1-Machine D3196-1 as per Folio FA339 and Dwg D3196Identify as D3196-12-Deburr

D3196-1 BAR

DRAWING NO. D3196	TITLE BAR	REV. C	DART AEROSPACE LTD ENGINEERING ORDER	D.E.O. NO. D3196-C-1	SHEET NO. SHEET 1 OF 2	SCALE NTS
DRAWN <i>ASS</i>	CHECKED <i>[Signature]</i>	MFG. APPR. <i>[Signature]</i>	APPROVED <i>[Signature]</i>	DE APPR. <i>[Signature]</i>		
DATE 08.08.27	DATE 08.08.28	DATE 08.08.29	DATE 08.08.29	DATE 08.08.29	DATE 08.09.04

D3196-1 BAR

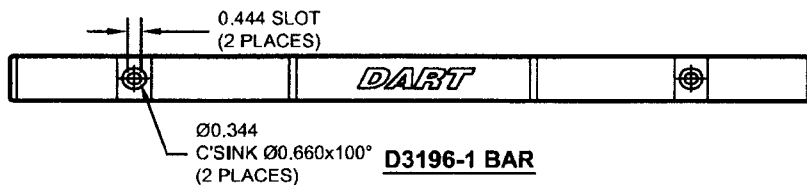
SHEET 1 MODIFY SLOT DIMENSIONING ON D3196-1 AS SHOWN:

D3196-3 BAR

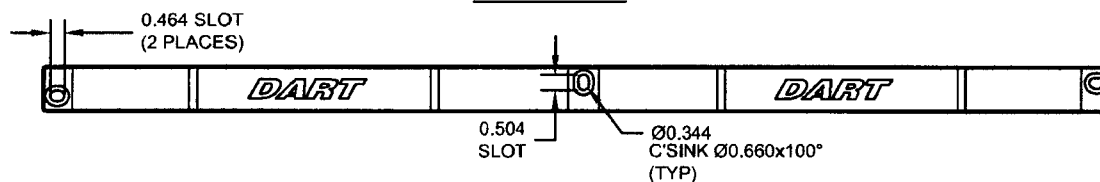
SHEET 2 MODIFY SLOT DIMENSIONING ON D3196-3 AS SHOWN:

D3196-4 BAR

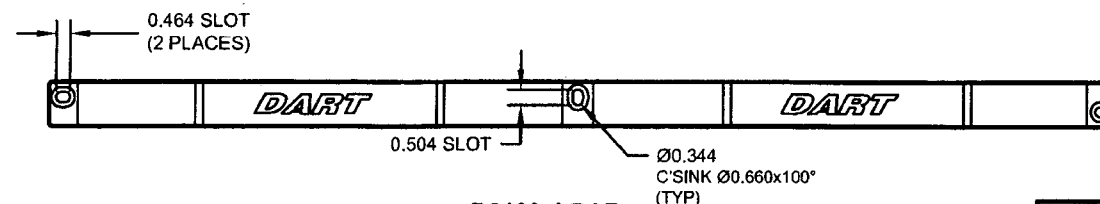
SHEET 3 MODIFY SLOT DIMENSIONING ON D3196-4 AS SHOWN:

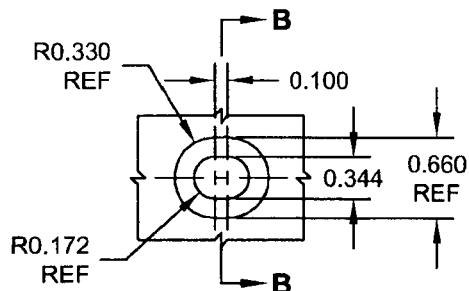
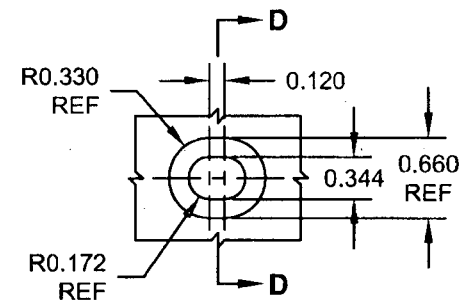
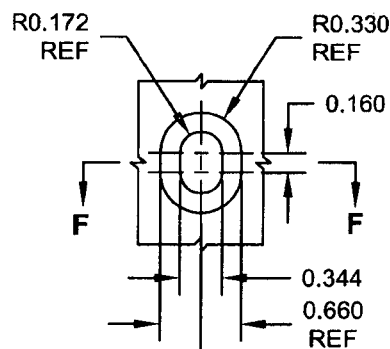
NOTE: THIS CHANGE HAS BEEN DONE TO CLARIFY SLOT DIMENSIONS ONLY. NO CHANGES HAVE BEEN MADE TO THE PARTS
SEE NCR 08-051 FOR FURTHER INFORMATION
ALL OTHER INFORMATION REMAINS UNCHANGED
